MONTGOMERY COUNTY PLANNING DEPARTMENT
THE MARYLAND-NATIONAL CAPITAL PARK AND PLANNING COMMISSION

MEMORANDUM

REVIEW TYPE: Preliminary Plan of Subdivision and Preliminary Water Quality Plan

PROJECT NAME: Rosewood Manor Estates

ROSEWOOD MANOR ESTATE
BLOCK 1, LOTS 35 & 36

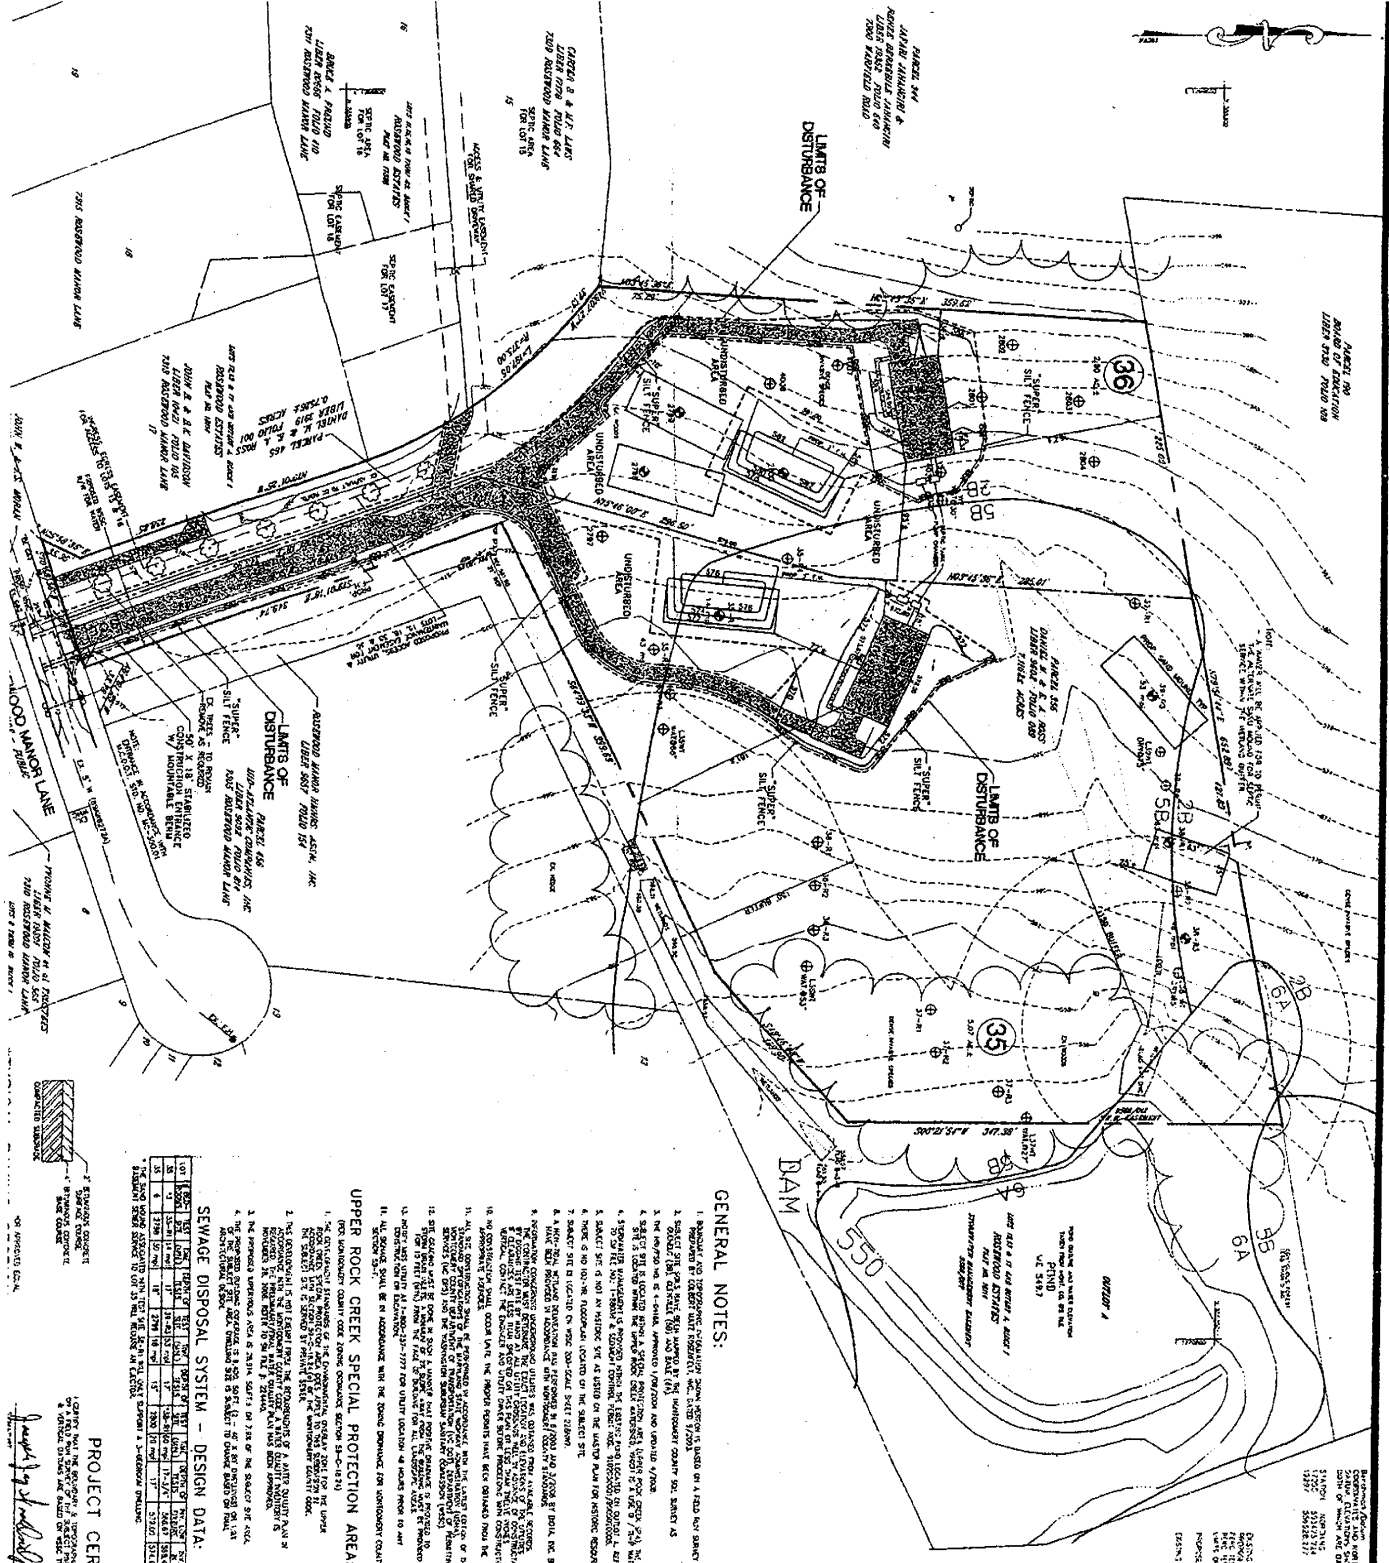
We have completed our review of the preliminary plan dated 04/06/06. This plan was reviewed by the Development Review Committee at its meeting on 05/06/06. We recommend approval of the plan subject to the following comments:

1. Show all existing planimetric and topographic details, specifically driveways adjacent and opposite the site on the preliminary plan.
2. Grant necessary slope and drainage easements. Slope easements are to be determined by study or set at the building restriction line.

3. Sand mound systems cannot be located within the right of way nor slope or drainage easements.
4. We did not receive complete analyses of the capacity of the downstream public storm system(s) and the impact of the post-development runoff on the system(s). As a result, we are unable to offer comments on the need for possible improvements to the system(s) by this applicant. Prior to approval of the record plat by the Department of Permitting Services (DPS), the applicant's consultant will need to submit this study, with computations, for review and approval by DPS. Analyze the capacity of the existing downstream public storm drain system and the impact of the post-development ten (10) year storm runoff on same. If the proposed subdivision drains to an existing closed section street, include spread and inlet efficiency computations in the impact analysis.

6. This site is located in Upper Rock Creek SPA, therefore we favor providing the access for the proposed lots from the existing driveway to reduce the impervious area. Please note DPWT access policy typically allows no more than four (4) lots to be served by a common driveway. A waiver package for any common driveway that provides access for more than 4 driveways is required. This waiver package should be provided according to DPWT requirements.

10. Revise the plan as necessary to meet the requirements of the Montgomery County Department of Permitting Services with regard to sand mound systems.
